Staff Report

Tentative Subdivision Plat

SD-03-24

September 12, 2024

Sheet **C2.0**
 SCALE: SEE BARSCALE

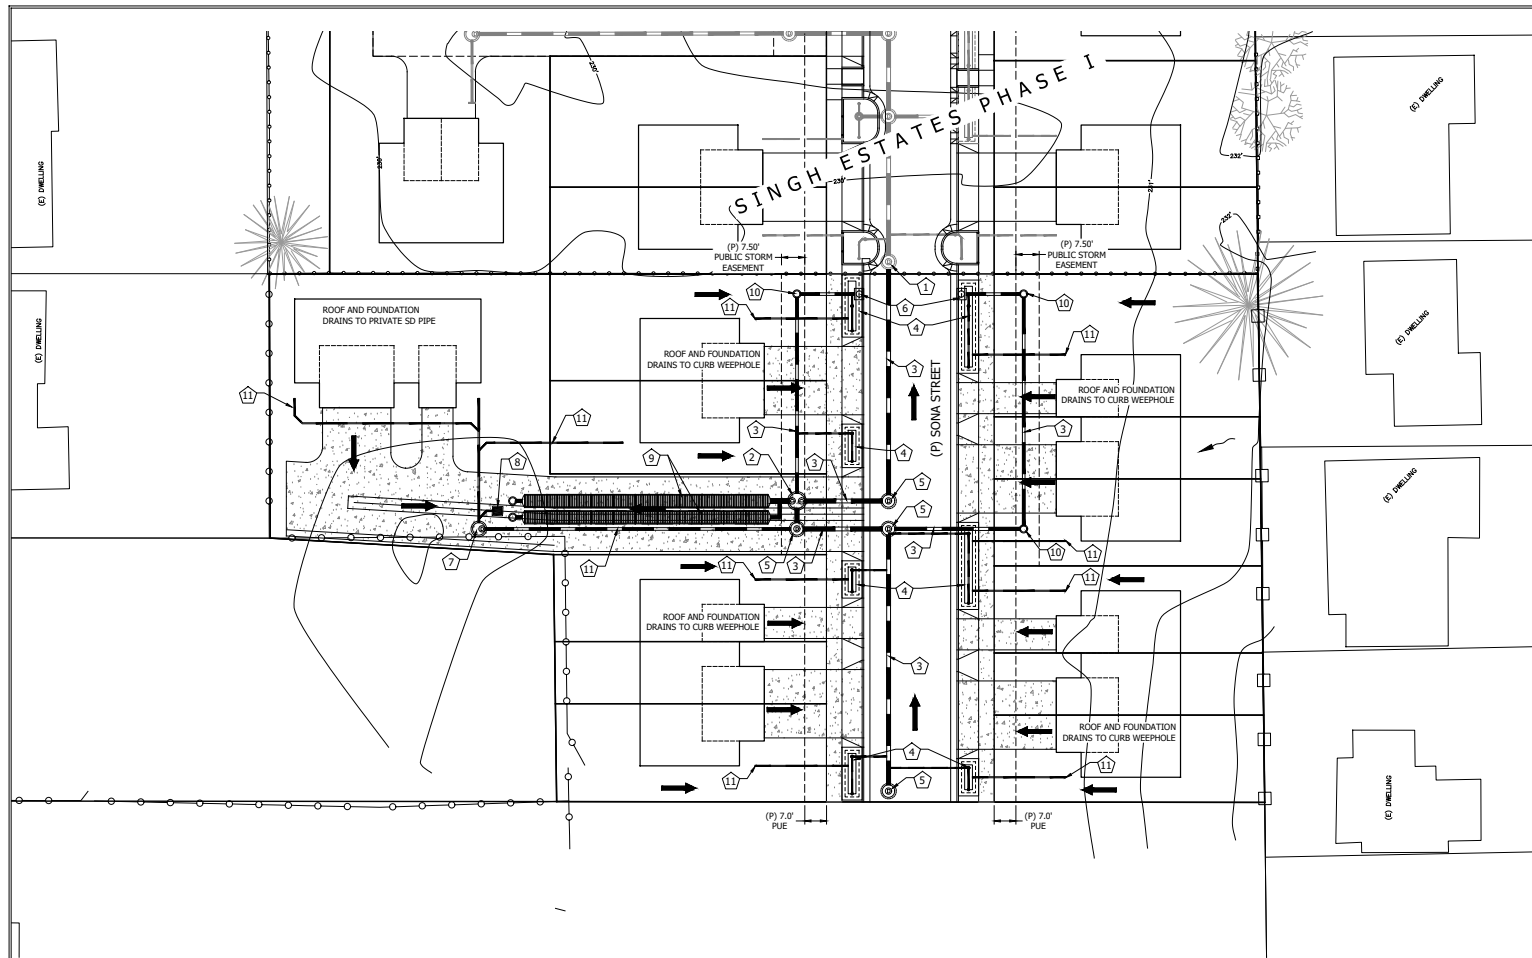
- 5.25 The applicant has submitted a preliminary drainage plan shows the installation of stormwater quality and detention facilities. The proposed drainage plan will connect to proposed Singh Estates Phase 1 storm drainage main. Final design details for these storm drainage facilities will be reviewed in conjunction with the subdivision. Before any work is done on or around a public storm drainage main the applicant must obtain a Site Improvement Permit from the Public Works Department.

- 5.4 The applicant must provide detention and stormwater quality facilities for the proposed development.
- 5.5 The applicant has submitted preliminary utility plans for the proposed development. While these plans appear to be generally acceptable, final design and construction details will be reviewed as part of the required permits.

- Condition 5 Before the City will approve the final subdivision plat, the applicant must obtain a stormwater quality permit and construct stormwater detention and stormwater quality facilities generally as detailed in the applicant's storm drainage report. However, final design details for these facilities will be reviewed and approved by the City as part of the stormwater quality permit and SI permit.

Sheet **C3.0**
 SCALE: SEE BARSCALE

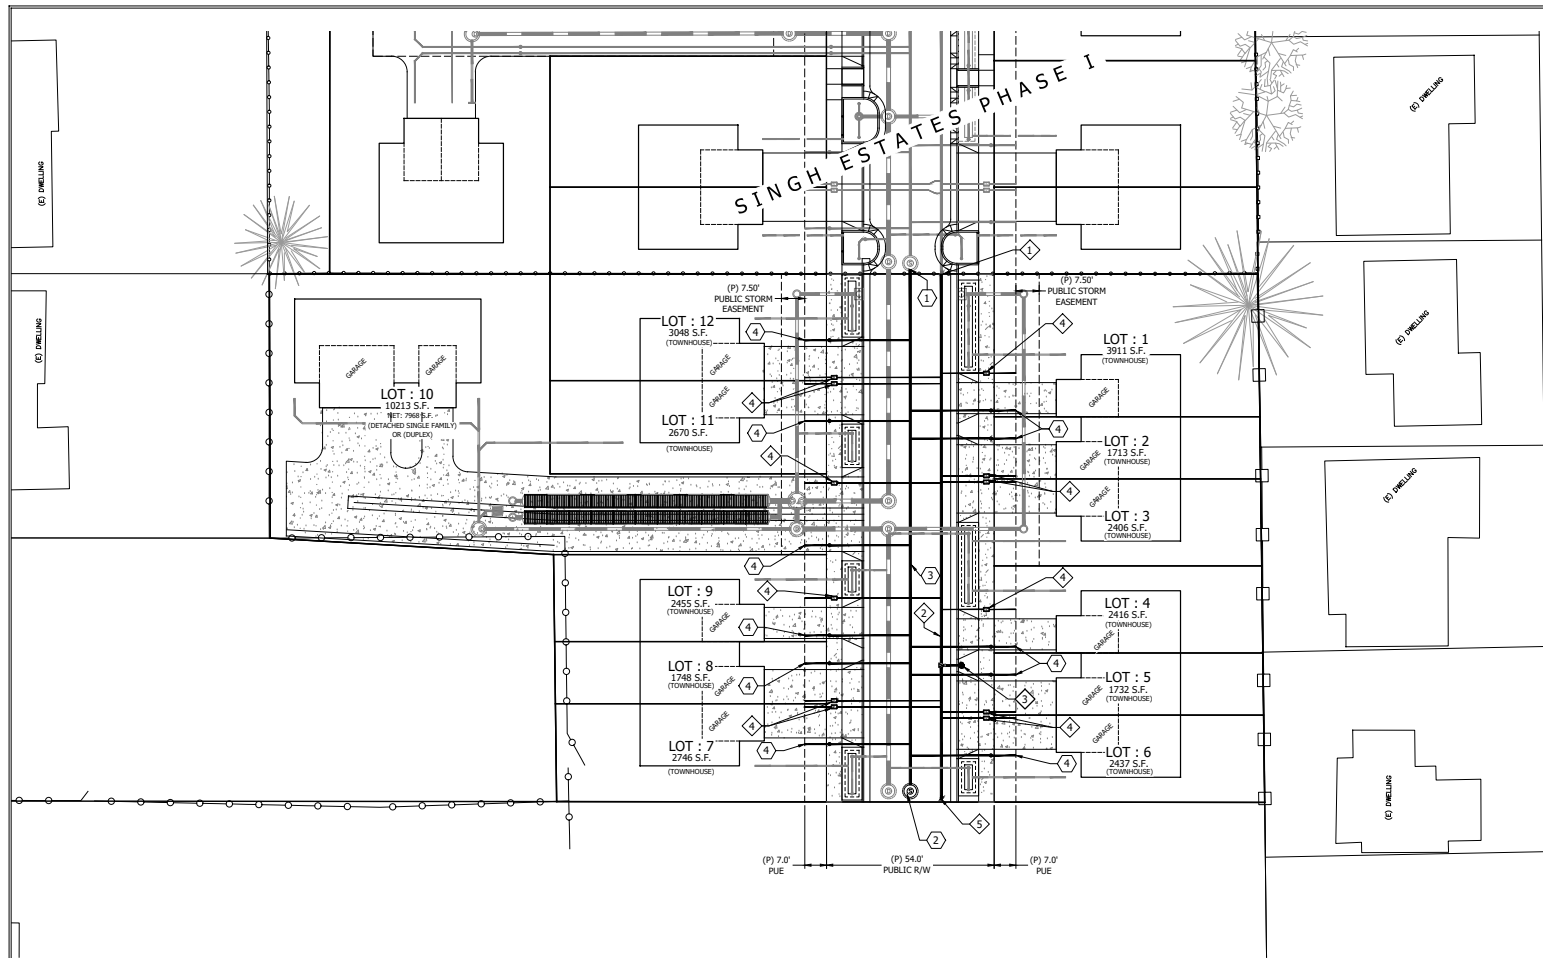
- 5.17 The applicant's preliminary utility plan shows the extension of an eight-inch water main in Bain Court SE to serve the subdivision from proposed Singh Estates Phase 1. Before any work is done on or around a public water main the applicant must obtain a Site Improvement Permit from the Public Works Department.

- 5.1 The applicant must extend public sanitary sewer facilities into the site from 22nd Avenue SE to serve each of the proposed lots and provide a connection to the property to the south for future development.

- 5.2 The applicant must extend public water facilities into the site from 22nd Avenue SE to serve each of the proposed lots and provide a connection to the property to the south for future development.

- Condition 3 Before the City will approve the final subdivision plat, the applicant must construct public sanitary sewer facilities to provide service to each of the proposed lots in the subdivision and provide for future extension to the property to the south.

- Condition 4 Before the City will approve the final subdivision plat, the applicant must construct public water facilities to provide service to each of the proposed lots in the subdivision and provide for future extension to the property to the south.
